SUBJECT: ISSUANCE OF AMENDMENTS- JOSEPH M. FARLEY NUCLEAR PLANT,
UNITS 1 AND 2 (TAC NO. M99610 AND M99612)

Amendment No. 132
License No. NPF-2

Amendment No. 124
License No. NPF-8

SAFETY EVALUATION BY THE OFFICE OF NUCLEAR REACTOR REGULATION
RELATED TO AMENDMENT NO. 132 TO FACILITY OPERATING LICENSE NO. NPF-2
AND AMENDMENT NO. 124 TO FACILITY OPERATING LICENSE NO. NPF-8
SOUTHERN NUCLEAR OPERATING COMPANY, INC., ET AL.
JOSEPH M. FARLEY NUCLEAR PLANT, UNITS 1 AND 2
DOCKET NOS. 50-348 AND 50-364

FIGURE 3.4-1

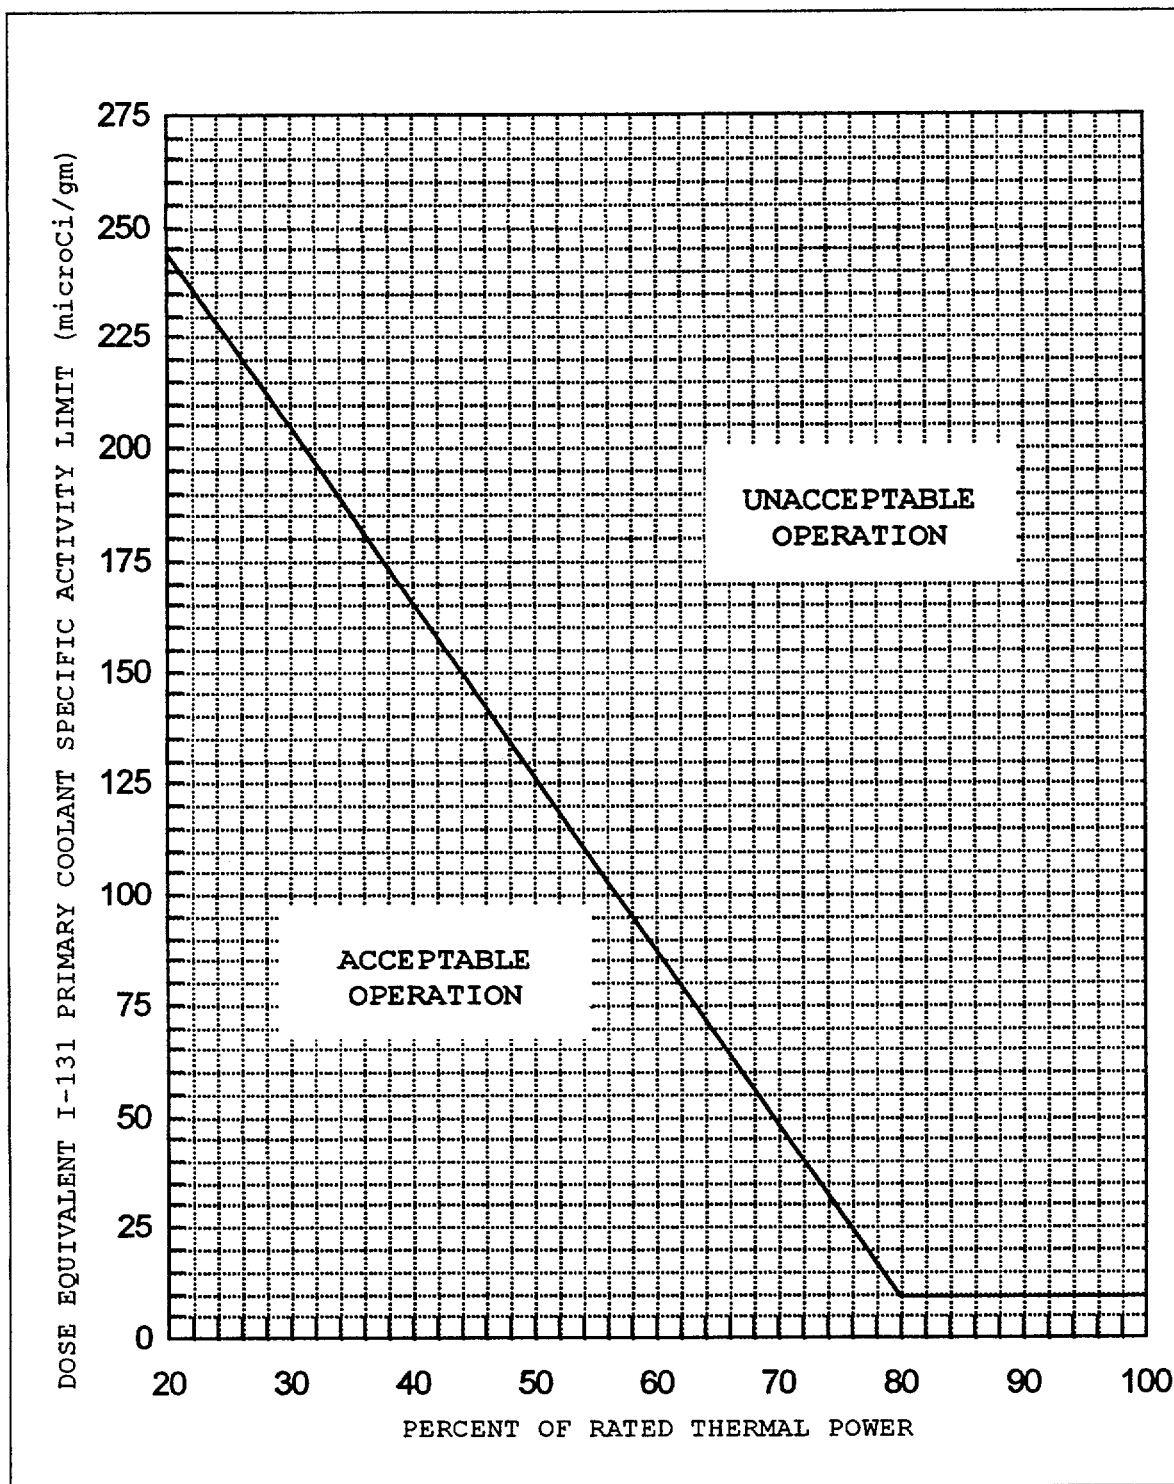
- a. With the specific activity of the primary coolant greater than 0.15 microCurie per gram DOSE EQUIVALENT I-131 for more than 48 hours during one continuous time interval or exceeding the limit line shown on Figure 3.4-1, be in at least HOT STANDBY with T_{avg} less than 500°F within 6 hours.
- b. With the specific activity of the primary coolant greater than $100/\bar{E}$ microCurie per gram, be in at least HOT STANDBY with T_{avg} less than 500°F within 6 hours.

The ACTION statement permitting POWER OPERATION to continue for limited time periods with the primary coolant's specific activity greater than 0.15 microCuries/gram DOSE EQUIVALENT I-131, but within the allowable limit shown on Figure 3.4-1, accommodates possible iodine spiking phenomenon which may occur following changes in THERMAL POWER.

DOSE EQUIVALENT I-131 Primary Coolant Specific Activity Limit Versus
Percent of RATED THERMAL POWER with the Primary Coolant Specific
Activity > 0.15 $\mu\text{Ci}/\text{gram}$ Dose Equivalent I-131

FIGURE 3.4-1

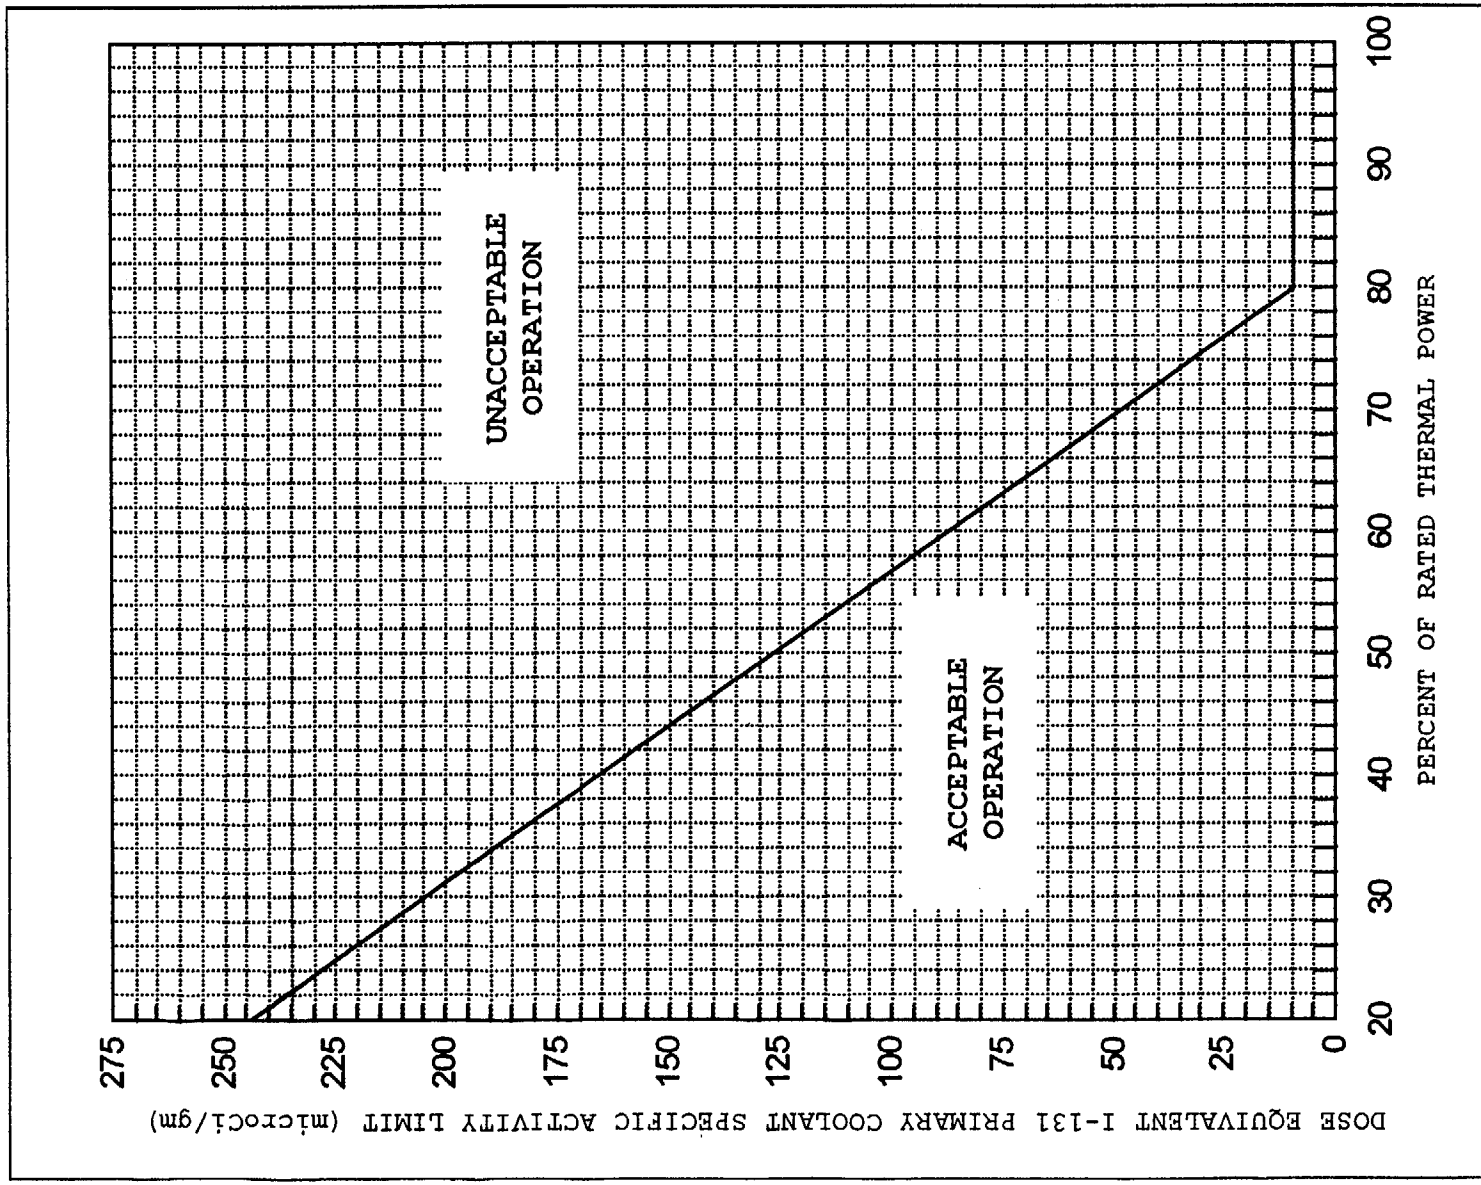
- a. With the specific activity of the primary coolant greater than 0.15 microCurie per gram DOSE EQUIVALENT I-131 for more than 48 hours during one continuous time interval or exceeding the limit shown on Figure 3.4-1, be in at least HOT STANDBY with T_{avg} less than 500°F within 6 hours.
- b. With the specific activity of the primary coolant greater than $100/\bar{E}$ microCurie per gram, be in at least HOT STANDBY with T_{avg} less than 500°F within 6 hours.

The ACTION statement permitting POWER OPERATION to continue for limited time periods with the primary coolant's specific activity greater than 0.15 | microCuries/gram DOSE EQUIVALENT I-131, but within the allowable limit shown on Figure 3.4-1, accommodates possible iodine spiking phenomenon which may occur following changes in THERMAL POWER.

DOSE EQUIVALENT I-131 Primary Coolant Specific Activity Limit Versus
Percent of Rated Thermal Power with the Primary Coolant Specific
Activity > 0.15 $\mu\text{Ci}/\text{gram}$ Dose Equivalent I-131
